Rattle –  
Rear of Vehicle Underbody –  
Repair Procedure

MODEL 1995-97 MY  
Sedan Range  
VIN 720001-812255

ILLUSTRATION 1

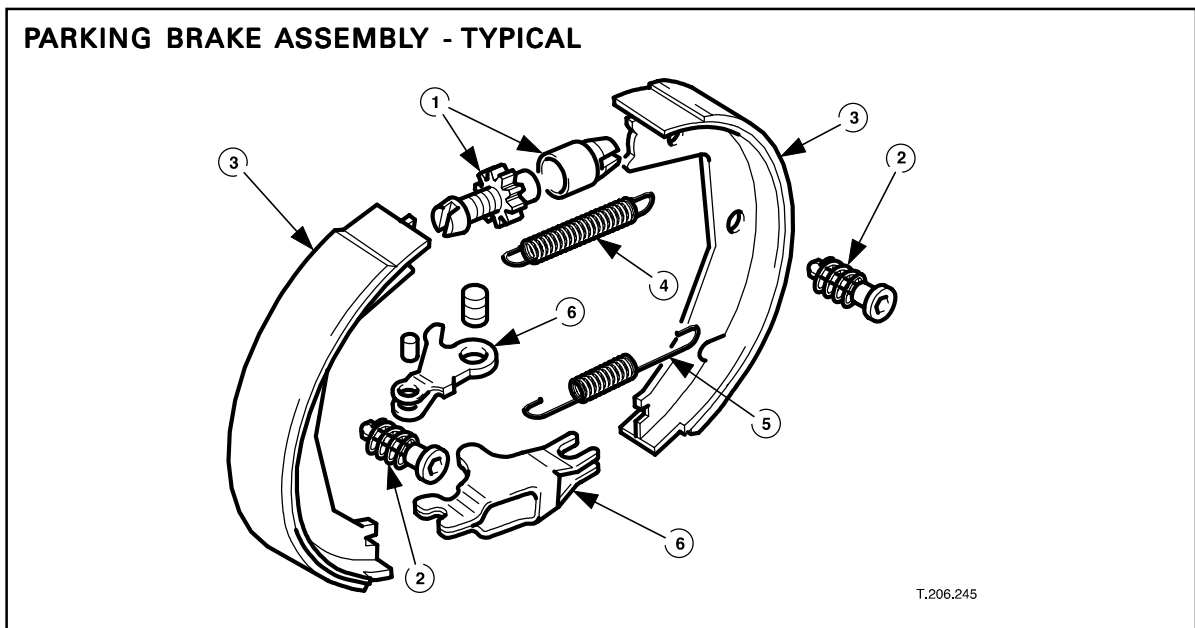
On 1995-97 MY Sedan Range vehicles, a rear-end underbody rattle may be caused by the parking brake mechanism.

Install rubber sleeves over each parking brake shoe lower return spring (Item 5, Illustration 1). The sleeves will exert pressure on the parking brake shoe spreader mechanism, to prevent it from rattling against the backing plate under certain conditions.

1. Raise and support the rear of the vehicle. Ensure that the parking brake is fully released.
2. Remove the rear wheels.
3. Disconnect the rear brake calipers, supporting them clear of the rear brake discs.
4. Without disturbing the adjustment of the parking brake shoes, remove the brake discs.
5. Release and remove the brake shoe lower return springs.
6. Slide a rubber sleeve over each spring. (See Parts Information).
7. Reinstall the springs, ensuring that the rubber sleeves are centered on each spring and that the sleeves exert a moderate pressure on the shoe spreader mechanism.
8. Reinstall the brake discs, pads, calipers and road wheels.
